Re: *Third Five-Year Review Report (2012-2017) for the Natick Soldier Systems Center*

FINAL 2017 THIRD FIVE-YEAR REVIEW REPORT
For
U.S. Army Natick Soldier Systems Center
Natick, Massachusetts

Natick Soldier Systems Center - Site Layout

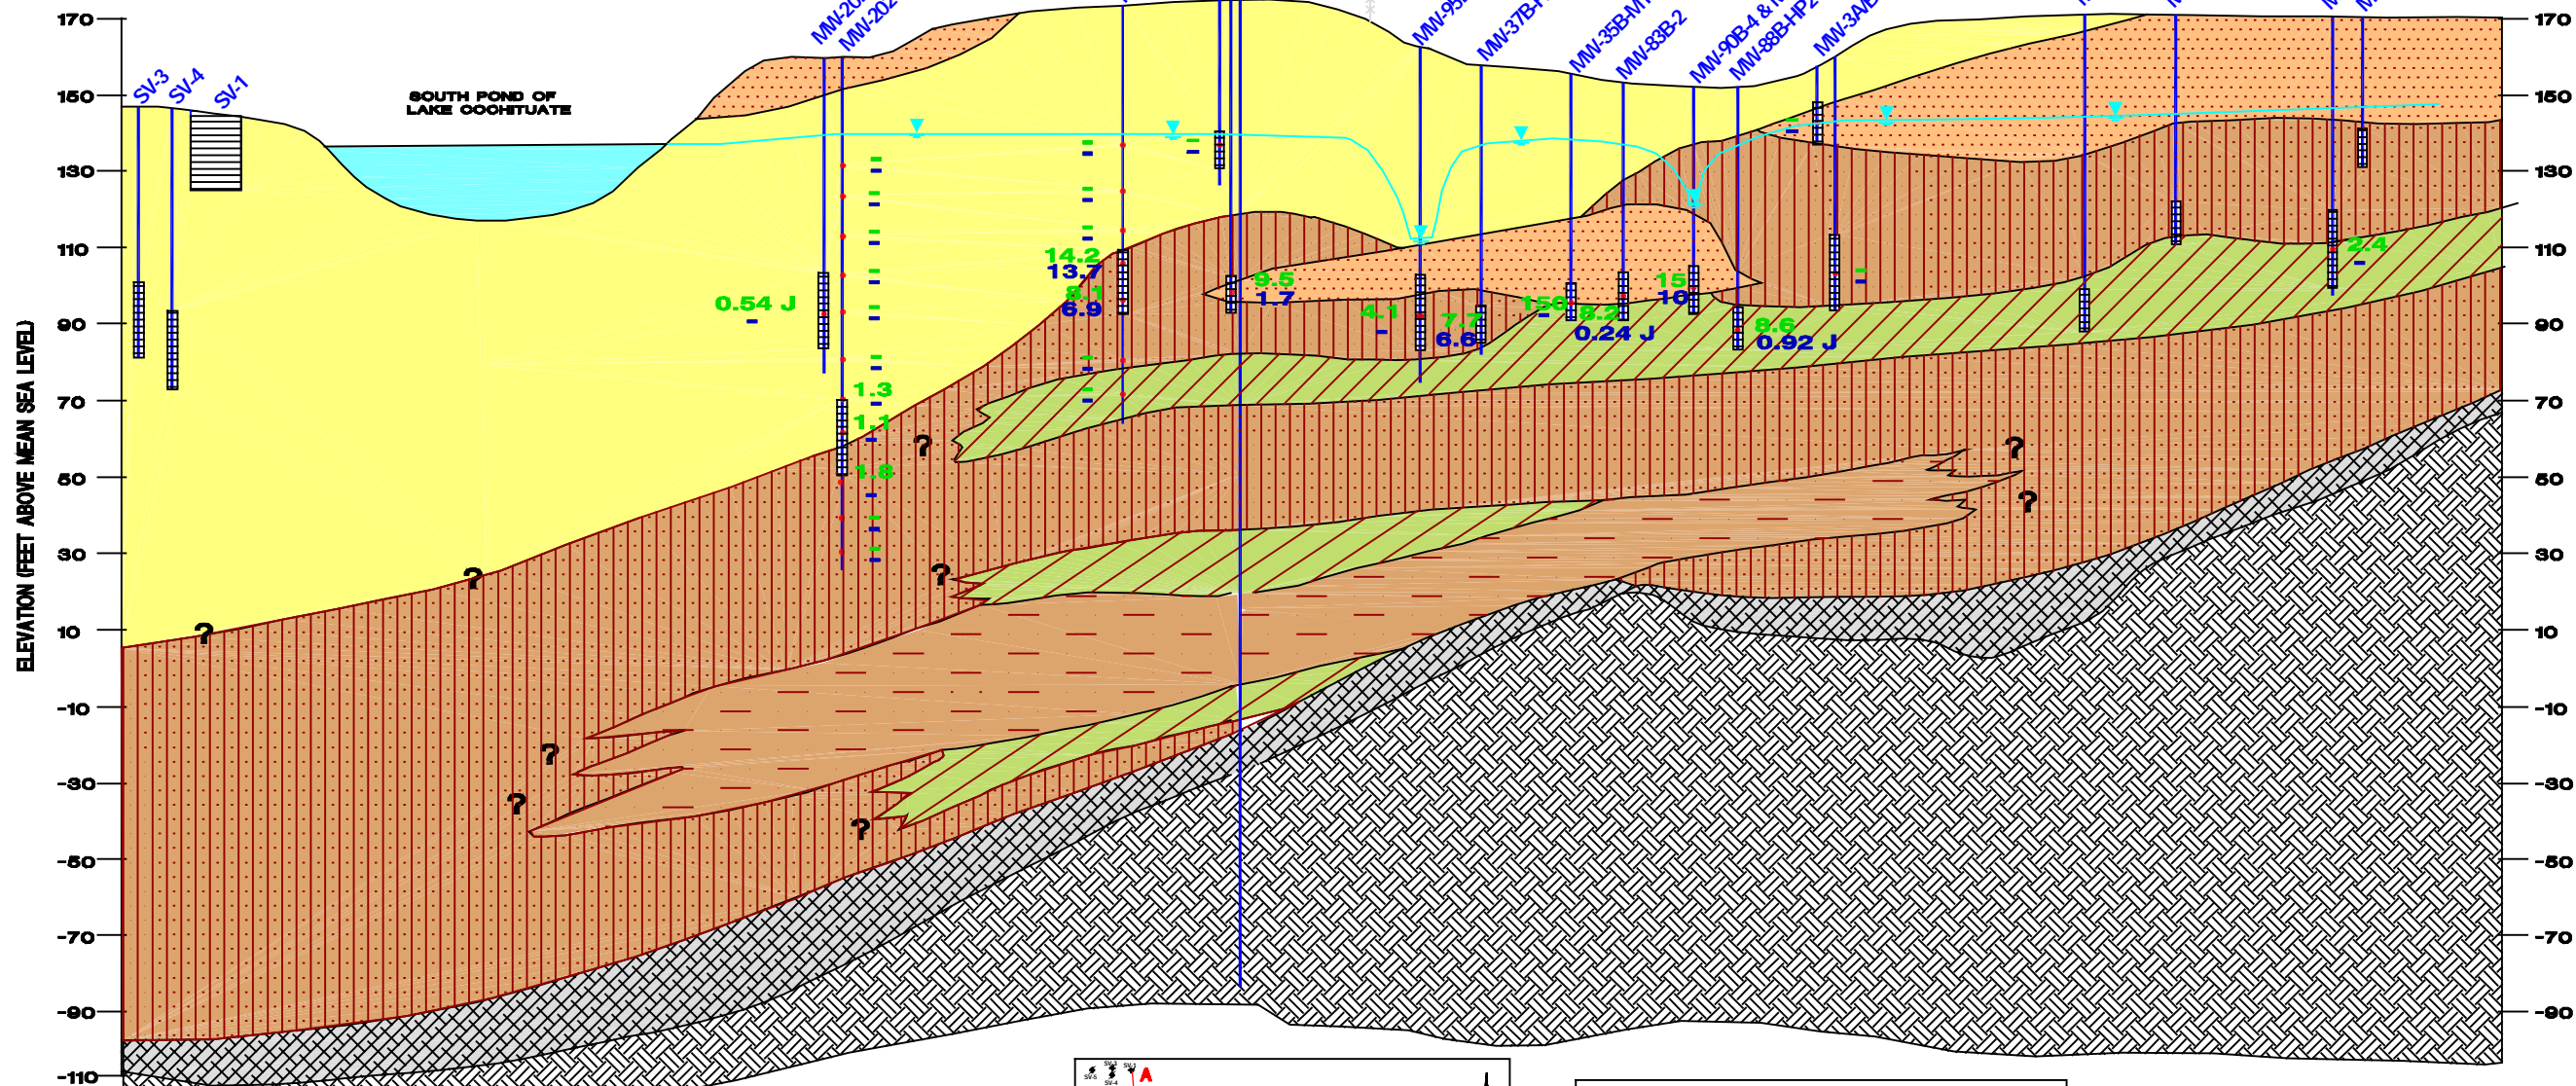
- 24. Figure 3 seems redundant. Figure 2 and figure 10 could be referenced in section 3.2 instead of Figures 2 and 3.**

1. Section 3.2 (History of Contamination): Comparison of Figures 2 and 3 suggests that remedial actions have been completed at several historic groundwater contamination sites (Boiler Plant Area, Water Supply Well Site, and Former Proposed Gymnasium Site); however, the report does not confirm or otherwise explain the status of these sites. To document the situation, please

1. To explain the status of the Boiler Plant Area, Water Supply Well Site, and Former Proposed Gymnasium Sites, which are identified in Figure 2, please add a brief discussion of the status of these sites to Section 3.2 (History of Contamination) of the report (refer to MassDEP Comment 1 and the Army's response to that comment).

Response: Figure 3 was included to compare the area of the plume specified in the ESD versus the earlier site designations on Figure 2.

FIGURE 6

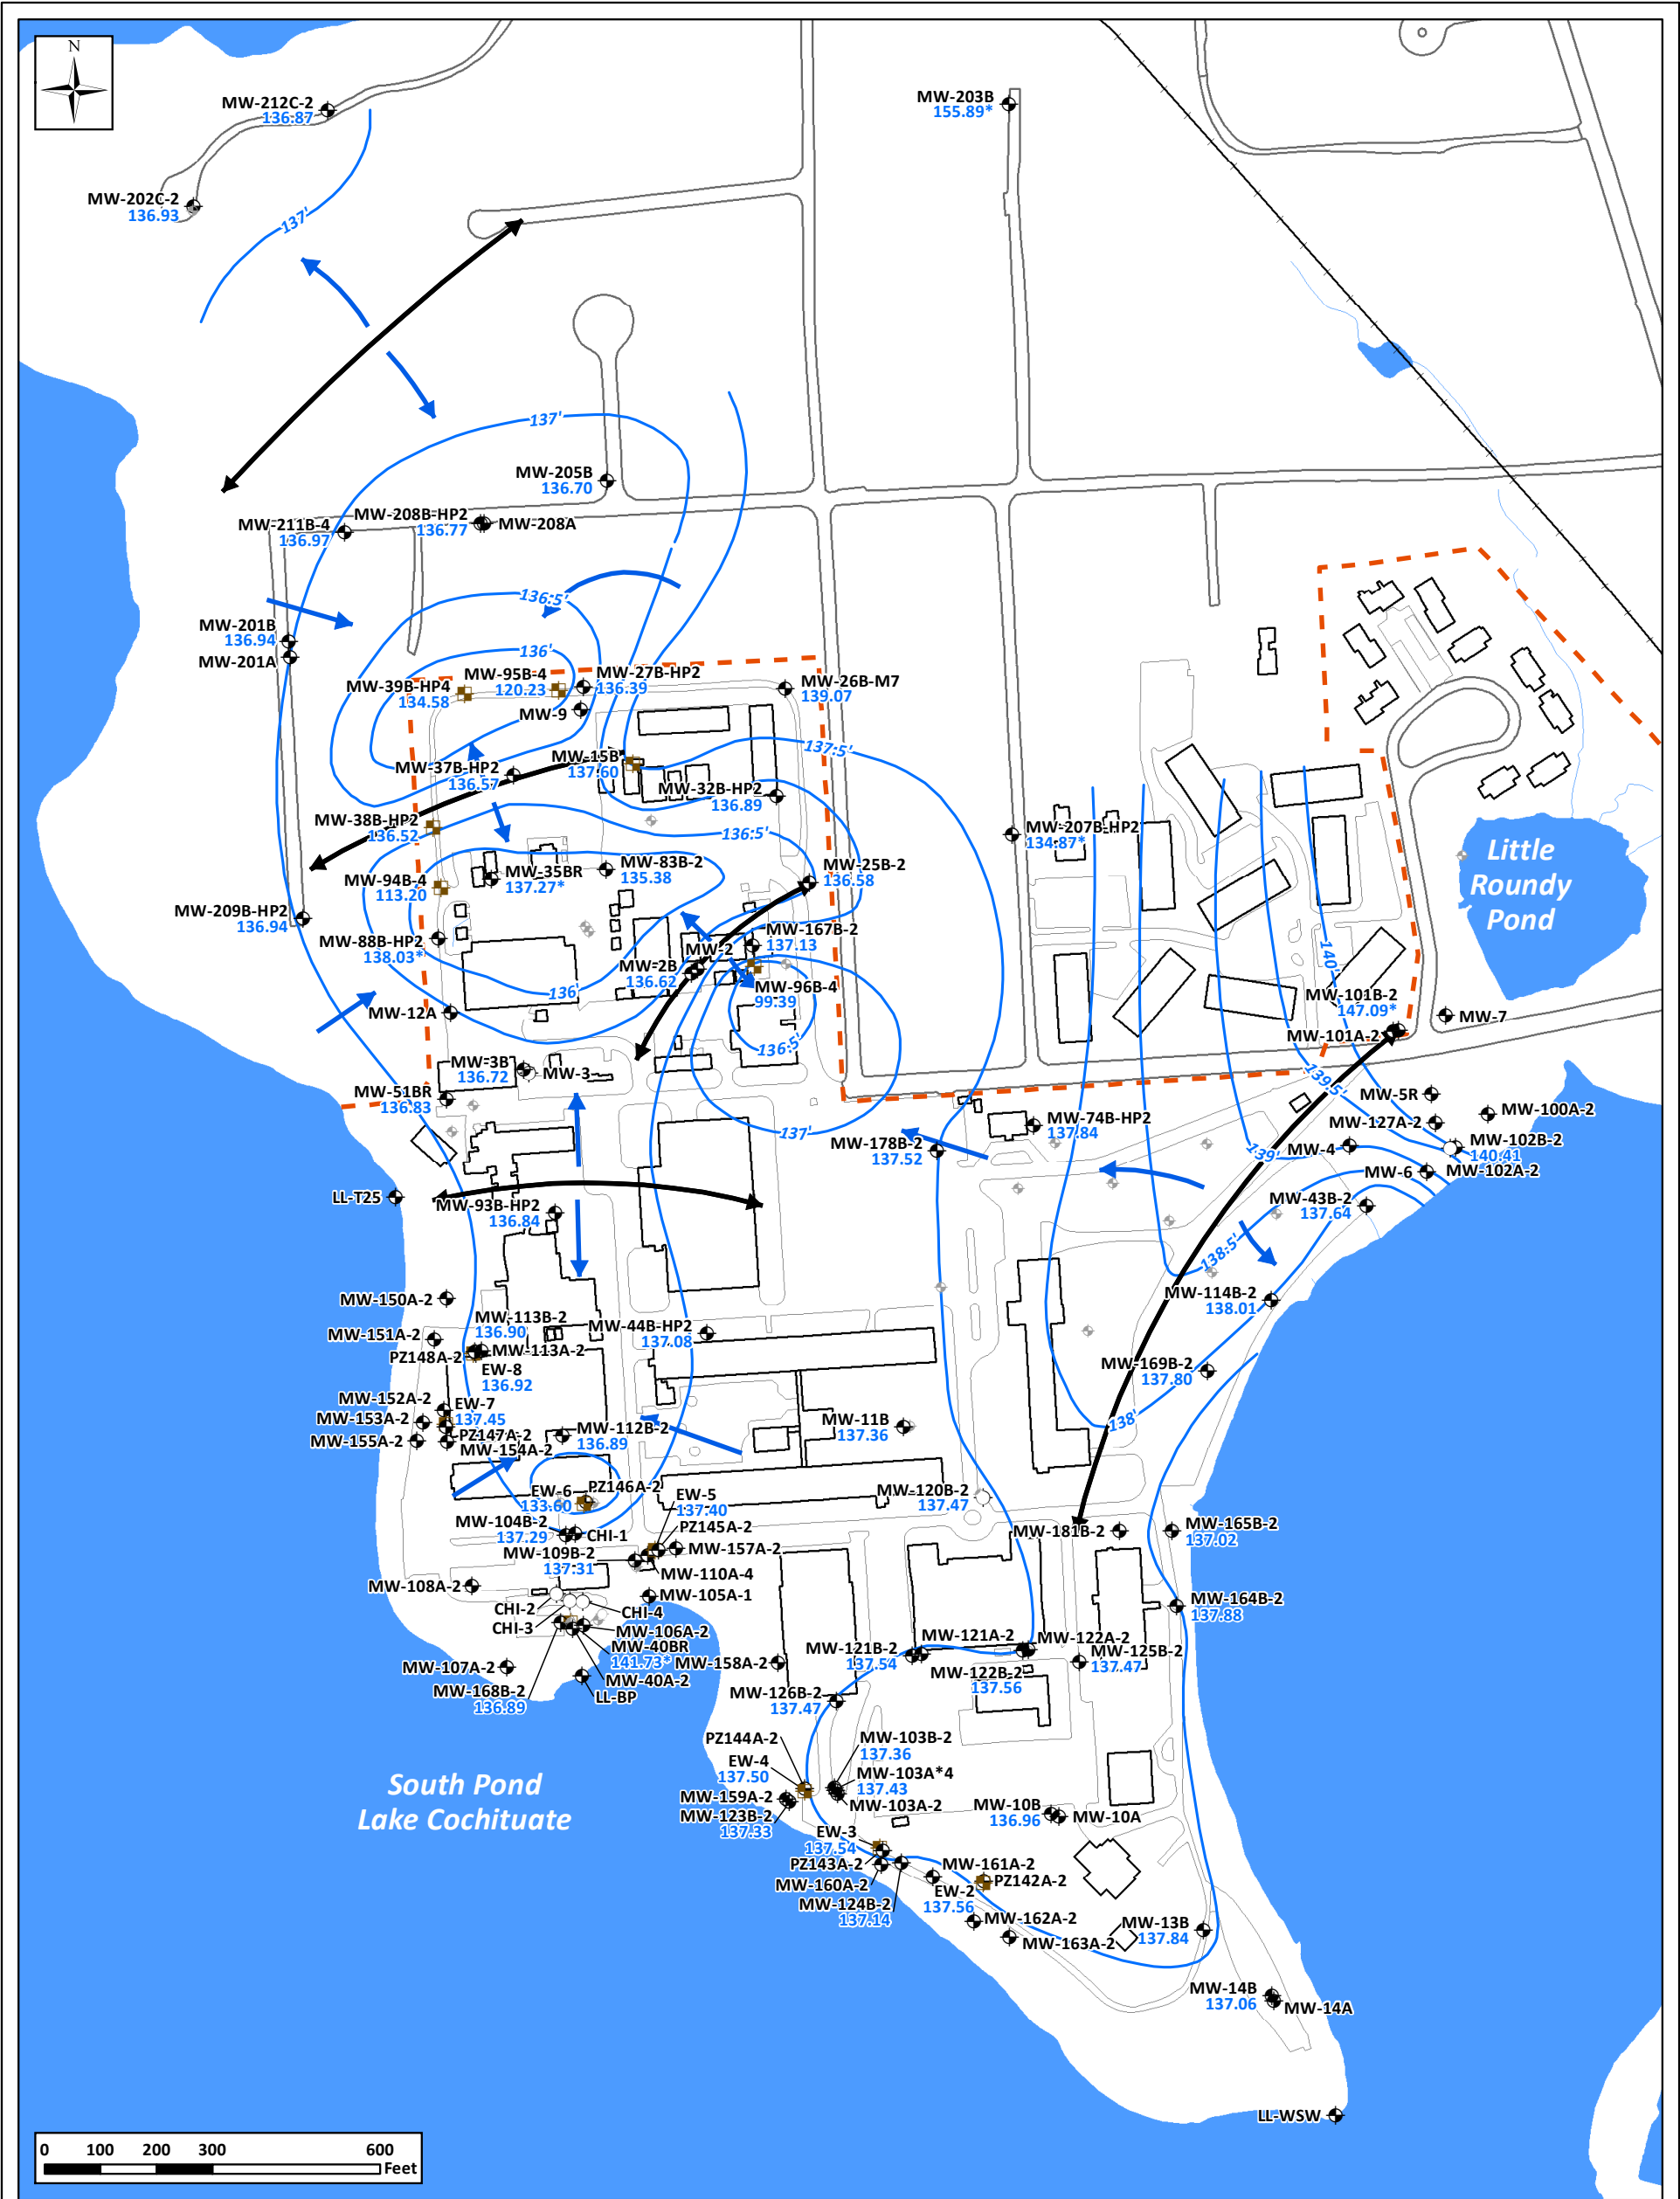
Response: Groundwater detected in monitoring well MW-125B-2 is on the other side of the groundwater divide (Figure 6), and outside of the influence of EW-3 and EW-4. Concentrations of TCE are detected above the MCL in this well and TCE is expected to discharge to Pegan Cove likely above MCLs prior to being diluted. Based on groundwater flow there are no other wells between MW-125B-2 and Pegan Cove. This area is being evaluated as part of the optimization work proposed by the Army for the Building 63, 2 and 45 Area.
